Co3072 – Jericho BF 0209(10)

ADDENDUM #1

REVISED: Plan Sheets 2, 5, 7, 23, 24, and 40 and Invitation for Bids.

PROJECT NAME: JERICHO
 PROJECT NUMBER: BF 0209(10)
 FILE NAME: sl2j634retaining wall details.dgn PLOT DATE: 5-NOV-2024
 PROJECT LEADER: R. YOUNG DRAWN BY: G. ROKES
 DESIGNED BY: A. MANN CHECKED BY: F. BARROWS
 RETAINING WALL DETAIL SHEET 40 OF 51

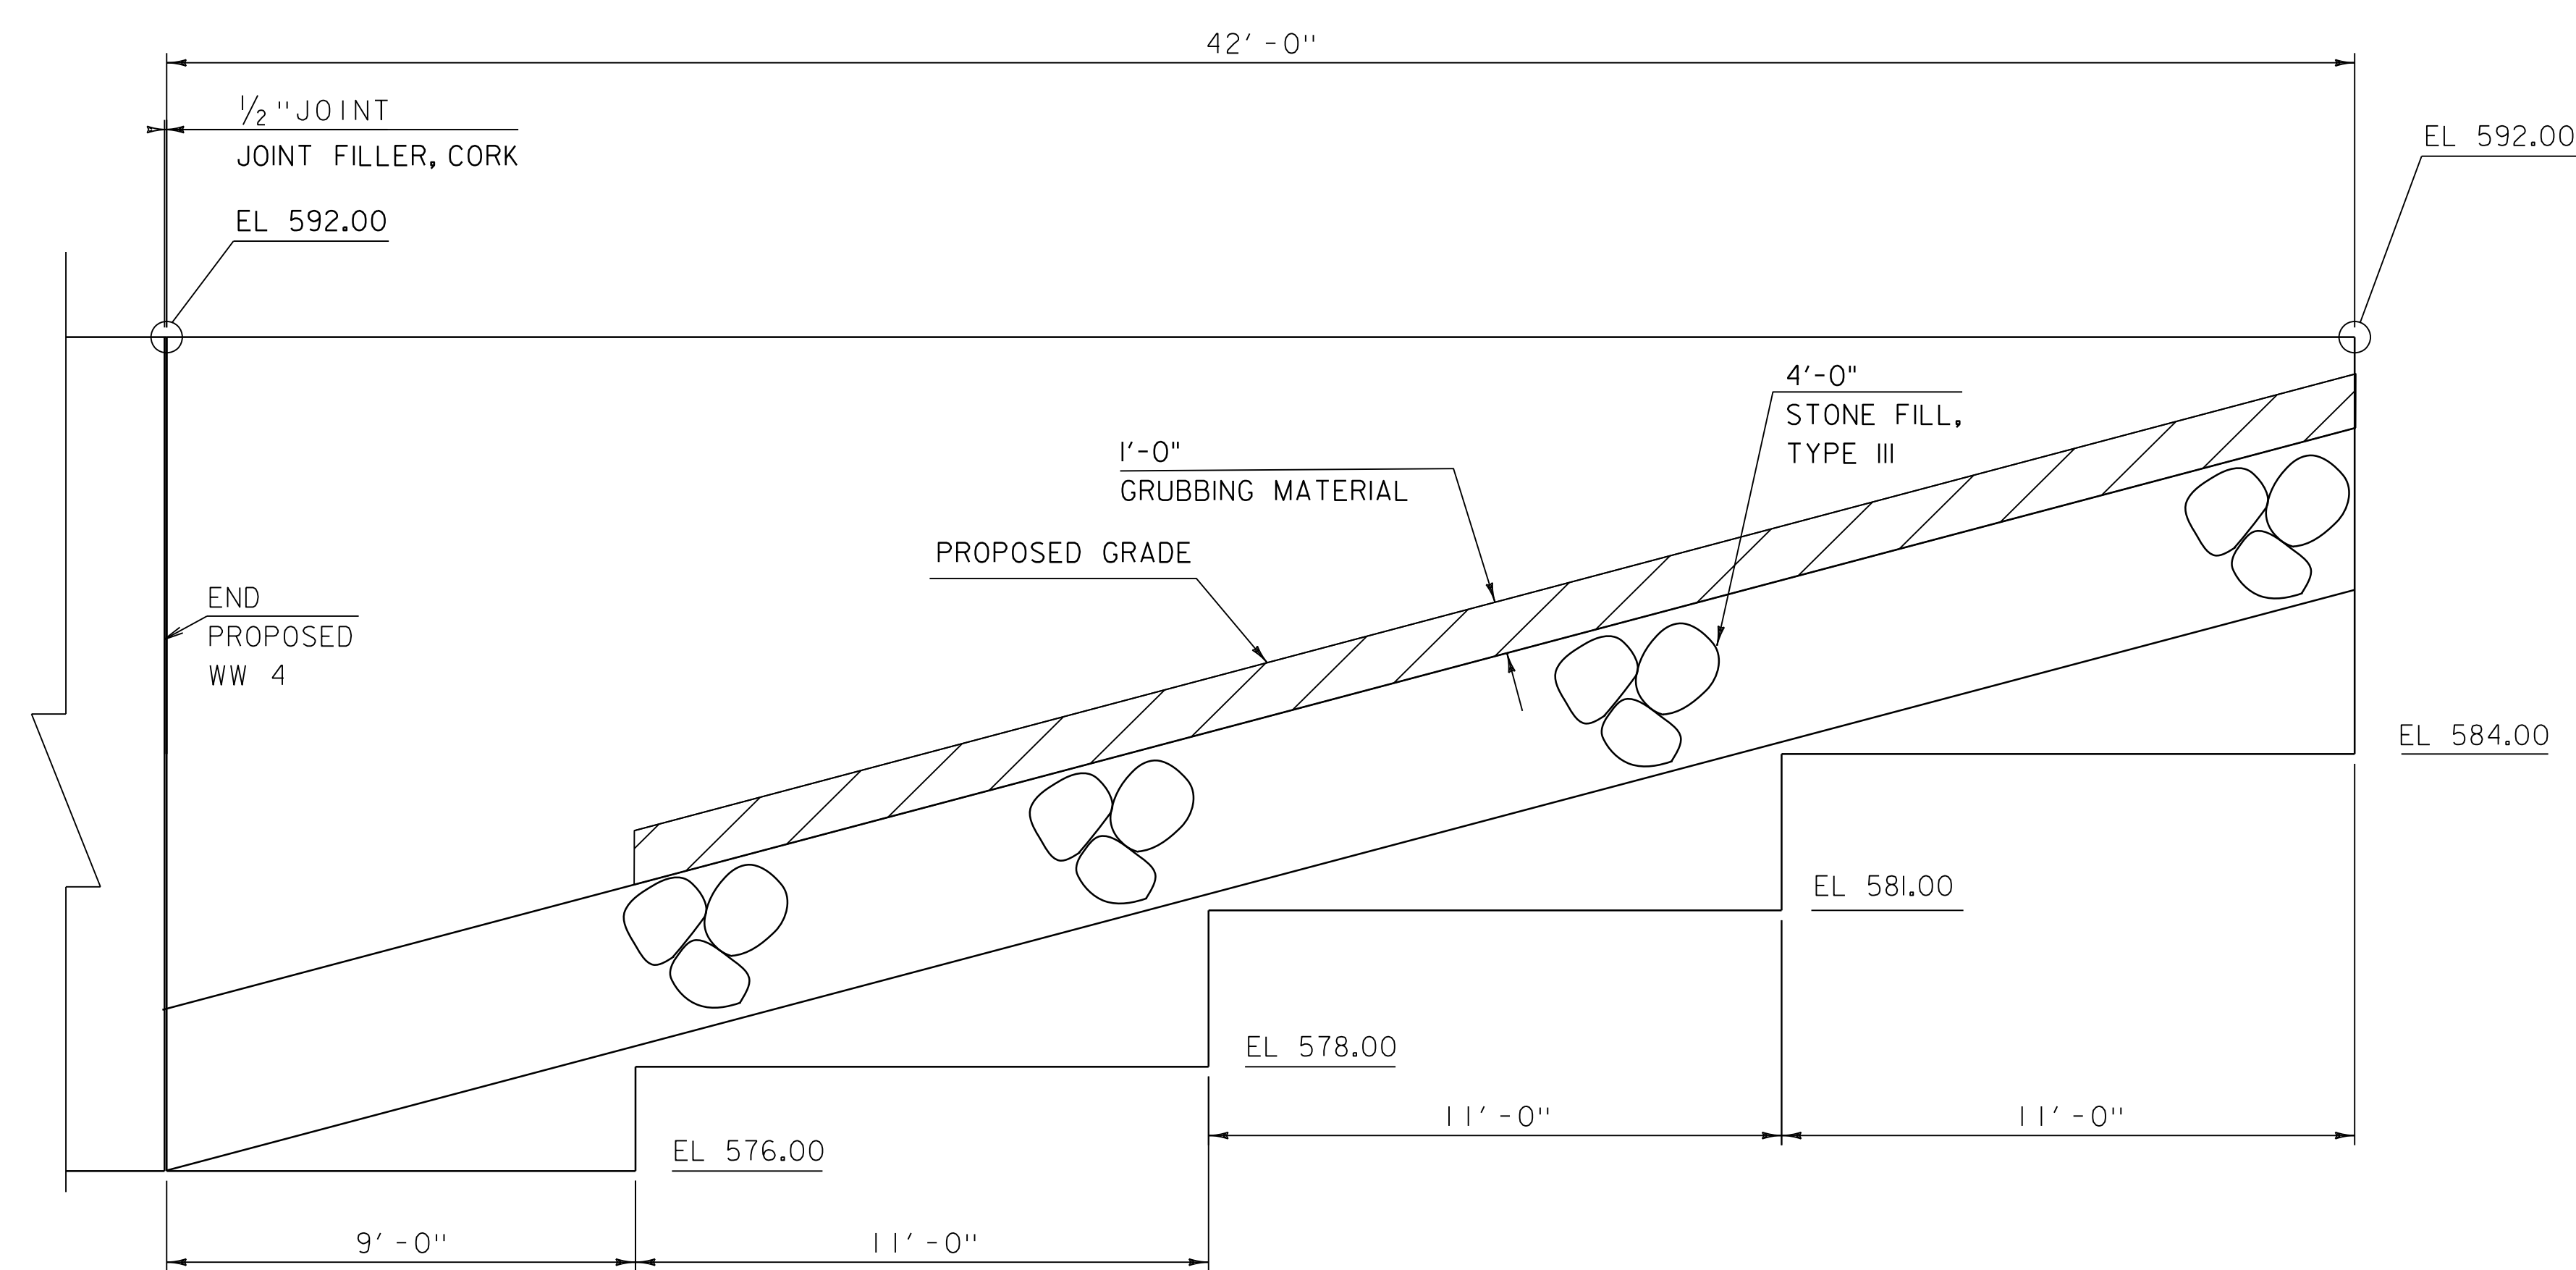
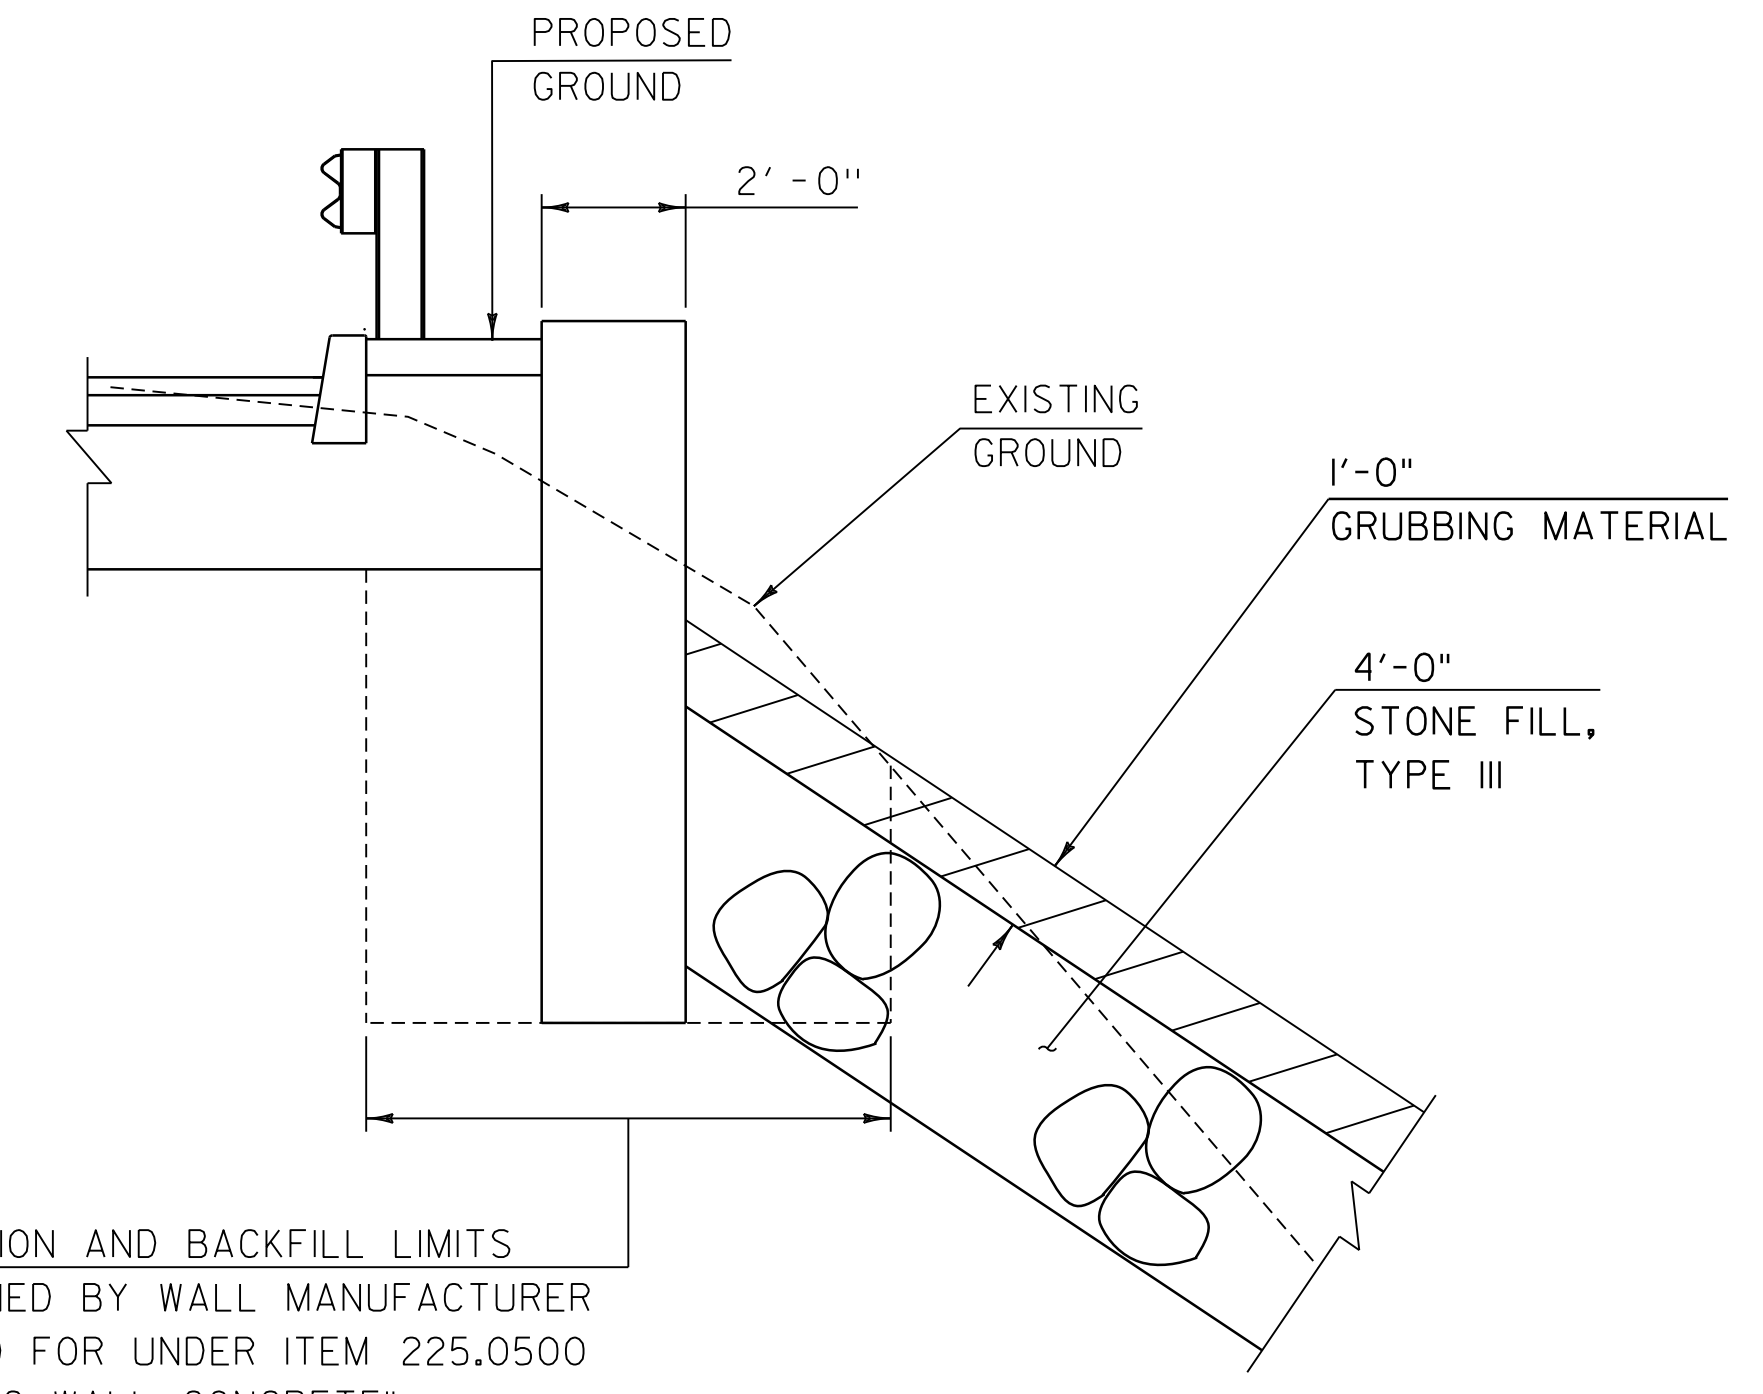
ADDENDUM	REVISION	DATE	BY	DESCRIPTION
△	I	11/05/2024	VAOT	WALL THICKNESS

2. DIMENSIONS ARE BASED ON A RETAINING WALL THICKNESS OF 2'-0". IF A DIFFERENT THICKNESS IS USED, GEOMETRY WILL NEED TO BE MODIFIED BY THE CONTRACTOR. THE EXPOSED FACE OF THE RETAINING WALL SHALL BE FLUSH WITH WINGWALL 4, REGARDLESS OF WALL THICKNESS.
